**SPECIFIC AGENDA WORDING: Consideration of Halff Engineering Flood Study Review No. 1, 2, and 3 and approval of road cut to be made in accord with such study to accommodate box culverts and drainage under County Road 805 from Villages of Mayfield Phase I in City of Cleburne in Johnson County, Texas.**

**Re: Villages of Mayfield Phase 1 – Flood Study Review #1**

**Re: Villages of Mayfield Phase 1 – Flood Study Review #2**

**Re: Villages of Mayfield Phase 1 – Flood Study Review #3**

FILE # P NHQ VILLAGES AT MAYFIELD 06122019  
 DRAWN FOR: CHUCK SED  
 SHEET 1 OF 3 DATE: 01/04/2019

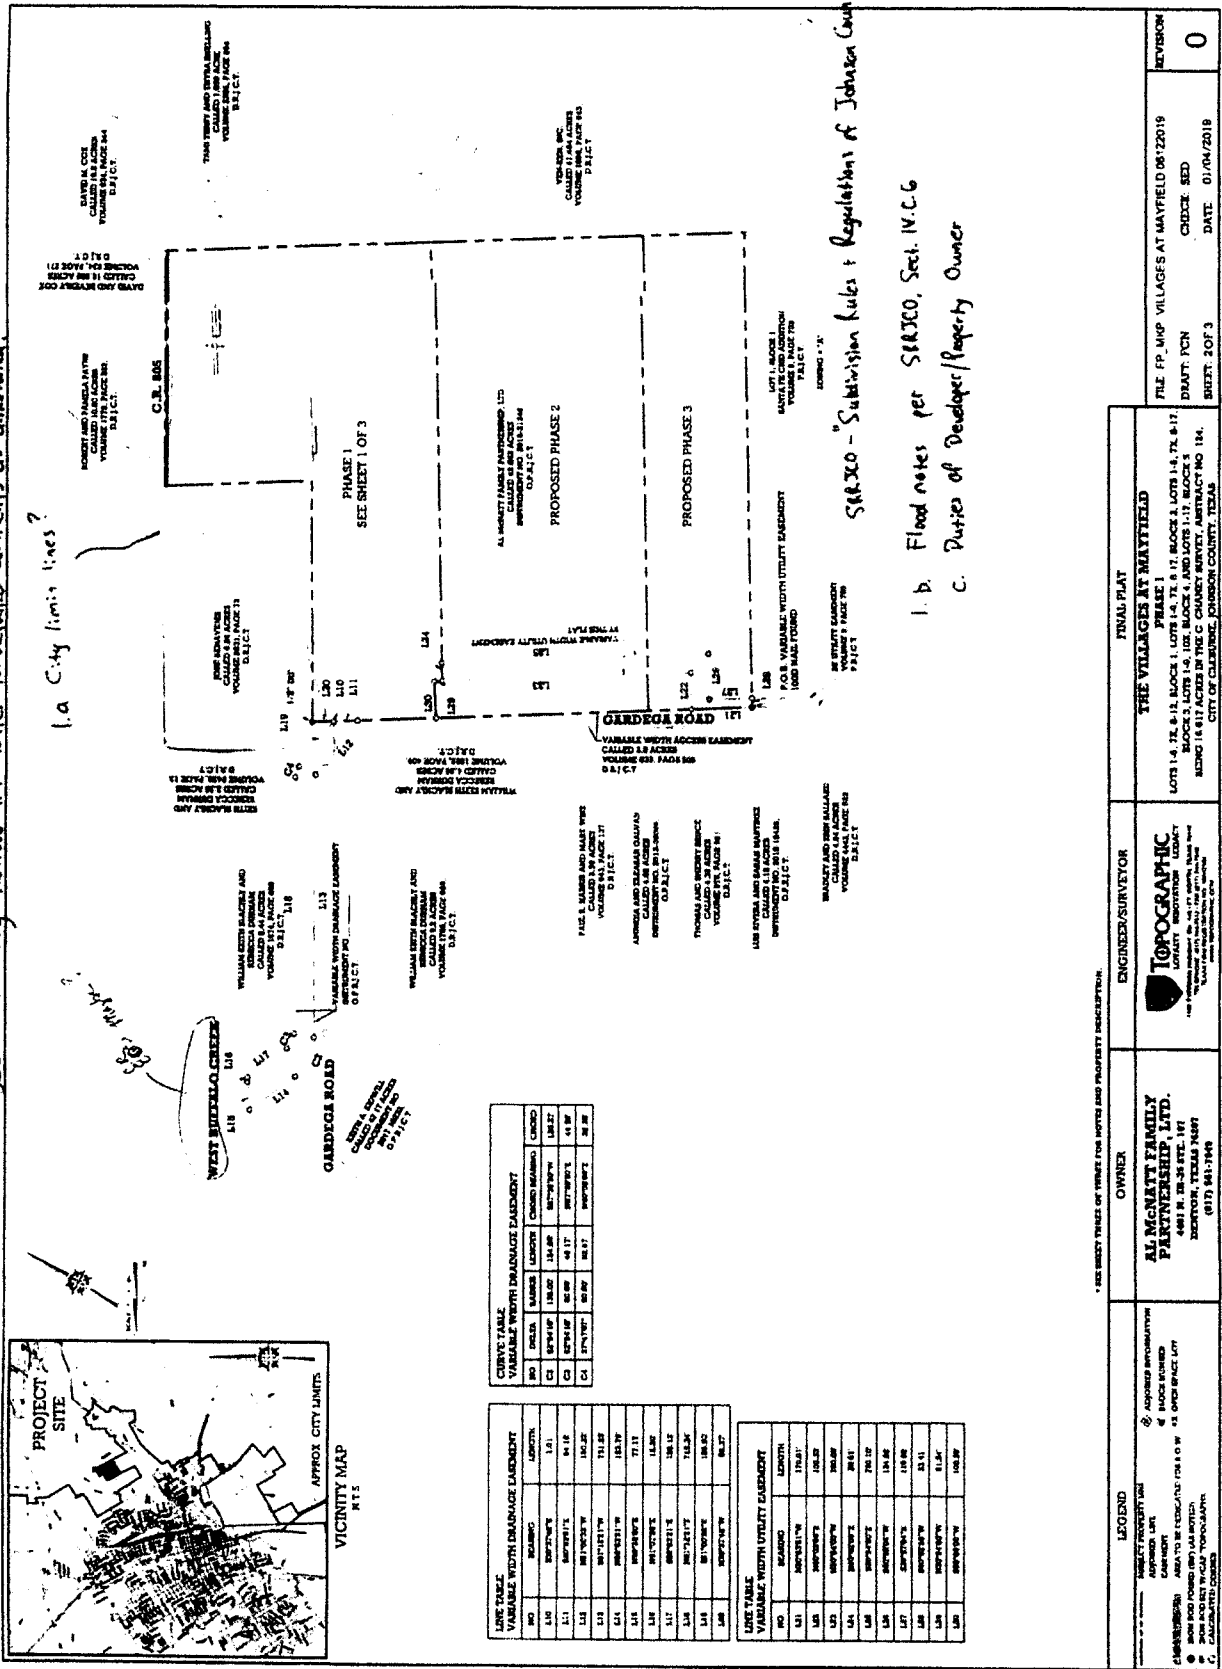
1. a. City limits lines?

SRR300 - Subdivision Rules & Regulations of Johnson County  
 1. b. Flood notes per SRR300, Sect. IV.C.6  
 c. Duties of Developer/Property Owner

FILE NO. MAP VILLAGES AT MATFIELD 06/22019  
 CHECKED BY: SED  
 DATE: 01/04/2018  
 SHEET: 2 OF 3  
 REVISION: 0

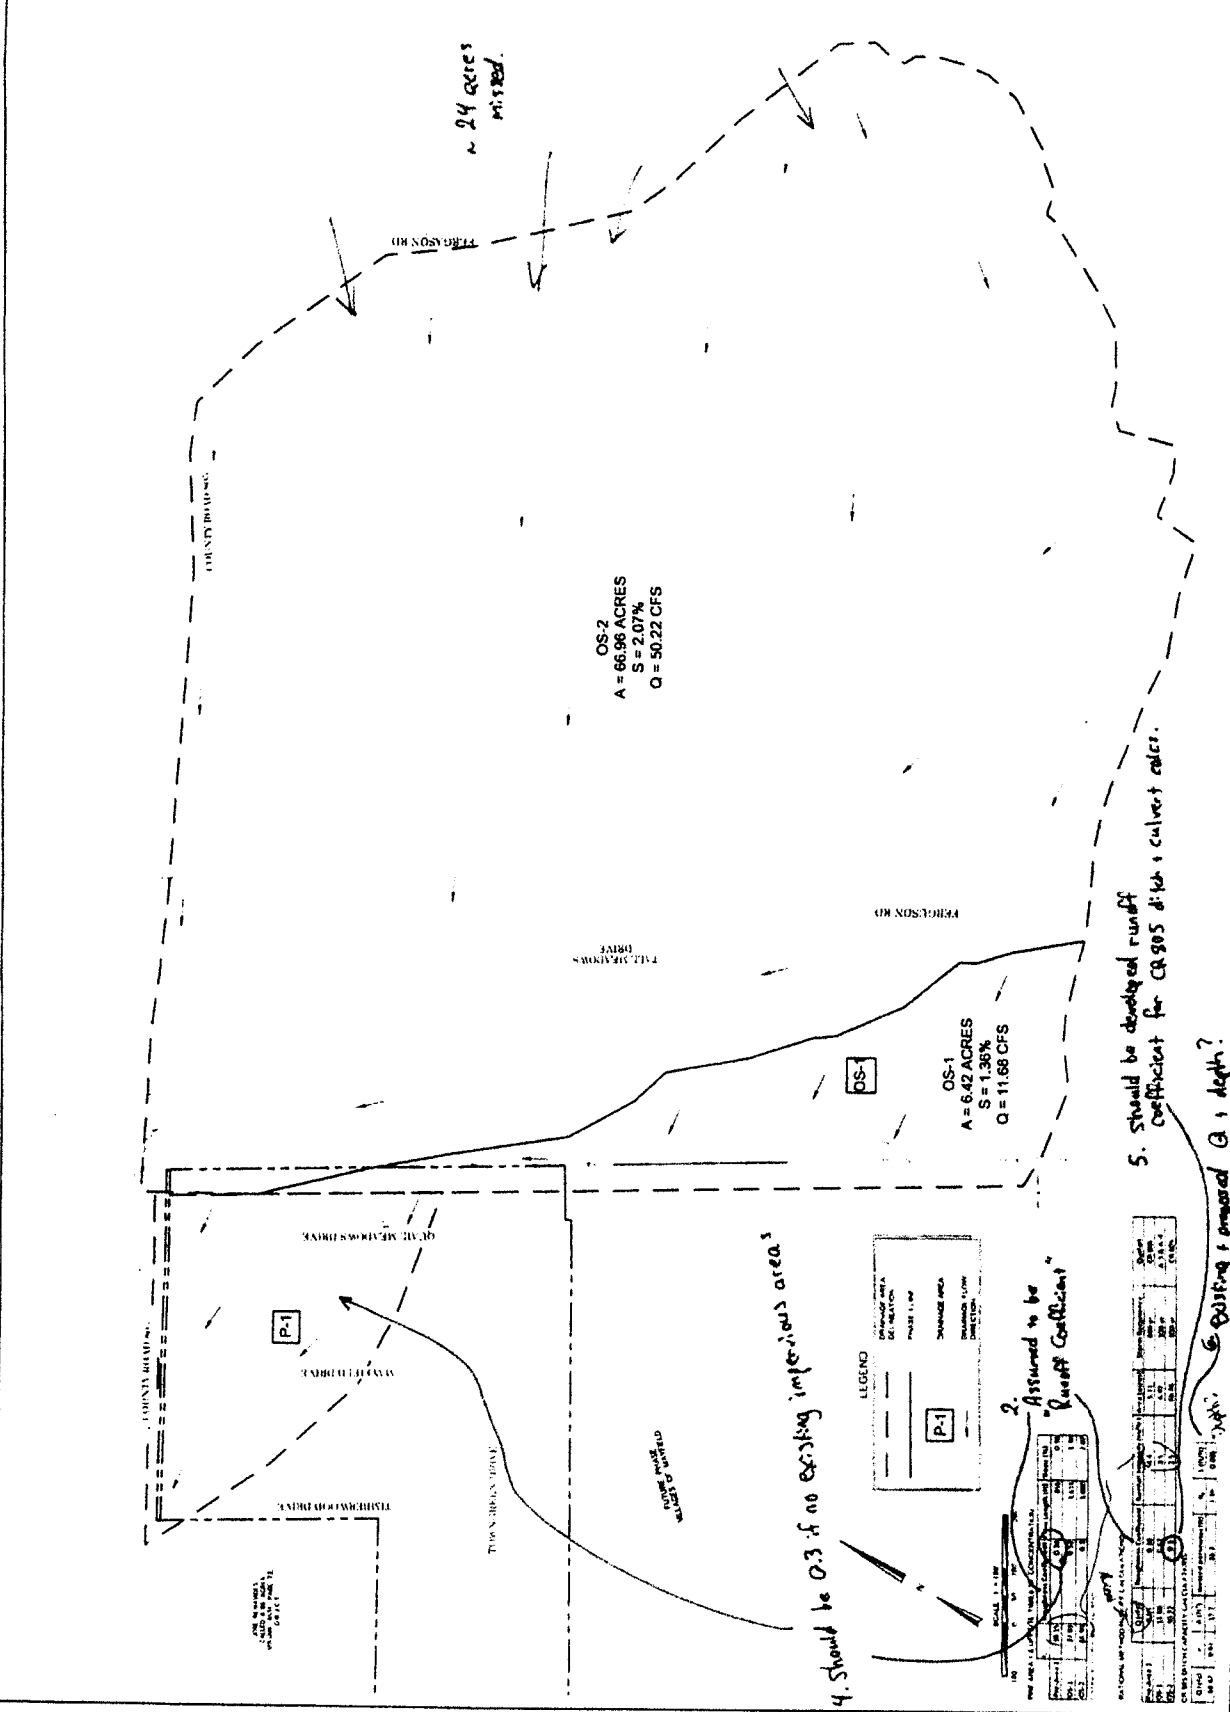
2. Assumed to be "P-1 Runoff Coefficient"

4. Should be 0.3 if no existing impervious areas

5. Should be developed runoff coefficient for CR90S at this culvert entry.

Existing proposed Q & depth?

## DRAINAGE AREA MAP

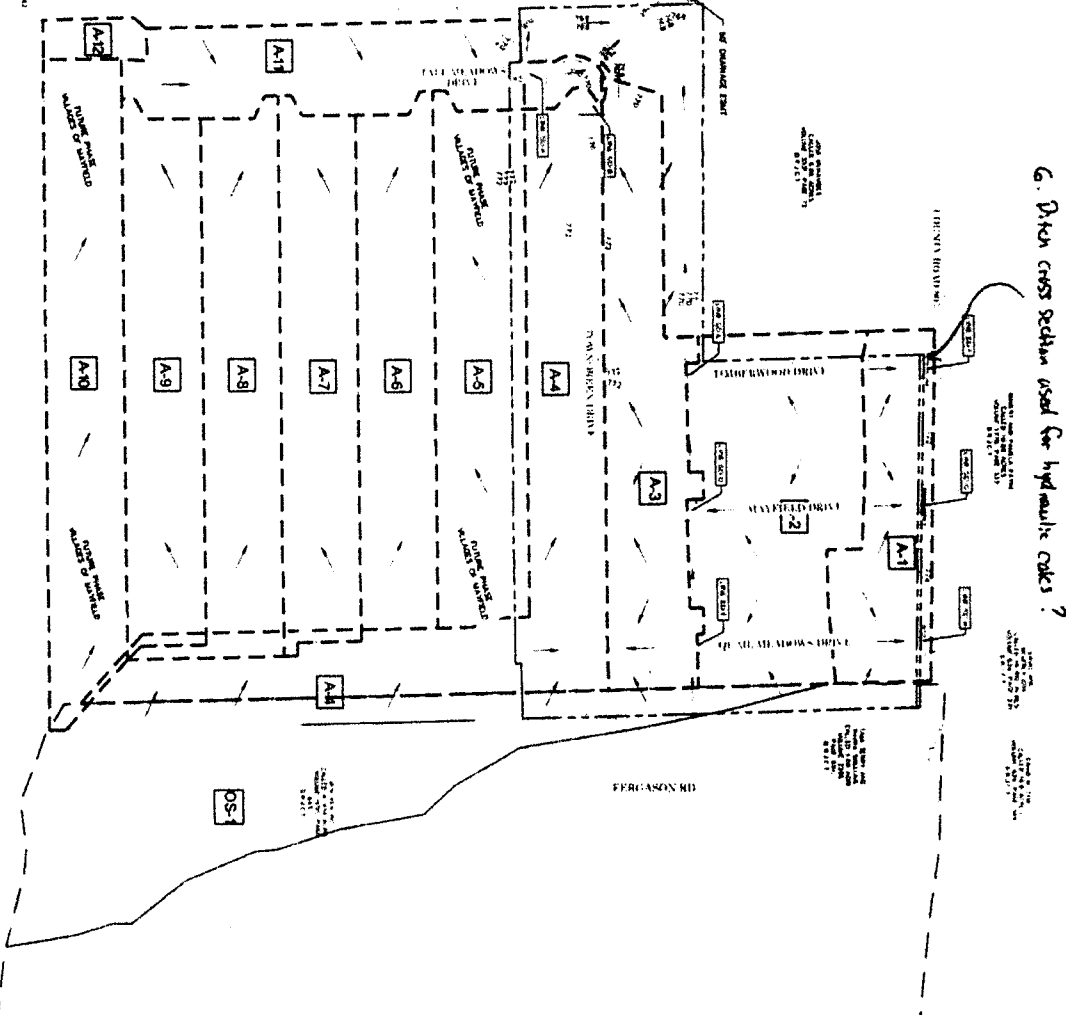
6. Given cross section used for hydraulic coker?

SHEET NO  
C-4.4

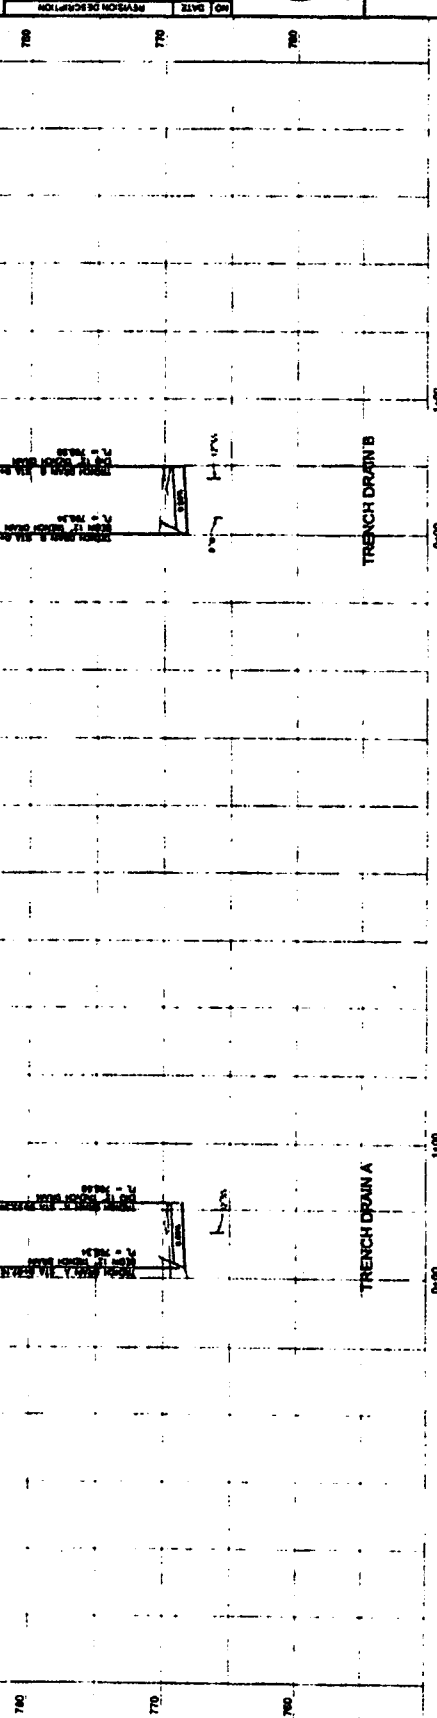
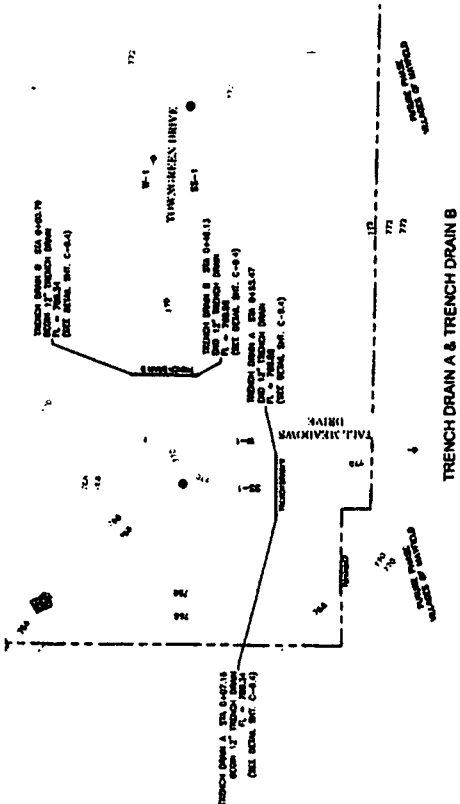
11. Show as 4x8 on C-47?

10. Should be 32 ft?

G. Data for CR 805 driveway culverts? Clarify if 5-yr flows used for culverts.

<b>VILLAGES OF MAYFIELD - PHASE I</b> <b>CLEBURNE, TEXAS</b>	<b>STORM DRAIN LINES SD-F SD-G &amp; SD-H</b>								
<b>C-4.6</b> SHEET NO.

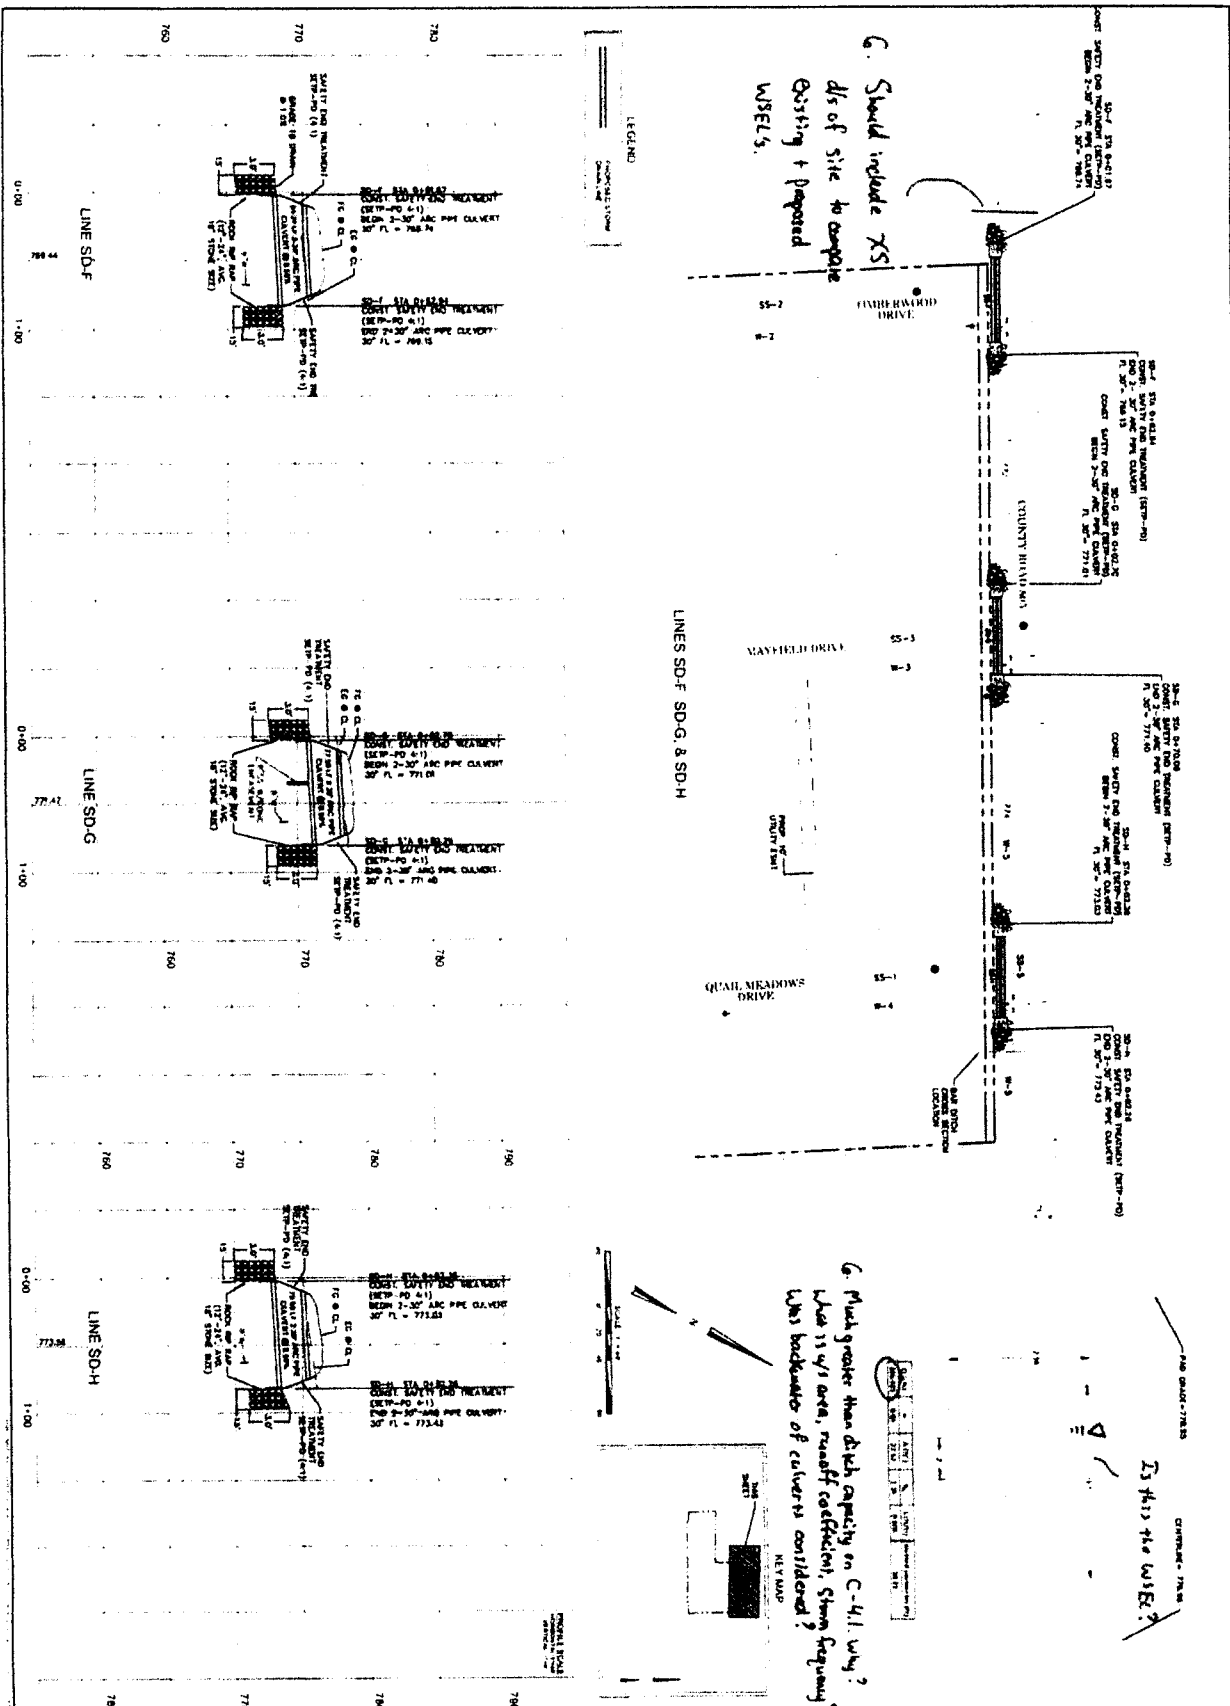
G. Should include XS  
 d/s of site to complete  
 Existing + proposed  
 WSELS.

G. Much greater than ditch capacity on C-41. Why?  
 What is yr area, runoff coefficient, Storm frequency?  
 What headwater of culverts considered?

Is this the culvert?
